Technical Newsletter

No:
34:1

New seal sleeves for cable diameters 10-26 mm on
Minex – Major & Salvador - Sandy

New Part number

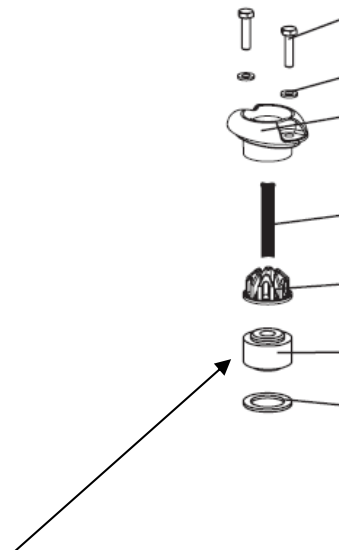
The seal sleeves for cable diameter 10-26 mm are modified to improve the cable entry on the pump models Minex, Minette, Salvador, Minor, Major, Senior & Sandy. Cable clips and washers remain same.

Improve the sealing of the cable entry for cables.

The new cable seal sleeve is fully replacing the old seal sleeve. The old spare parts are not automatically replaced, due to that they are still used in some other products.
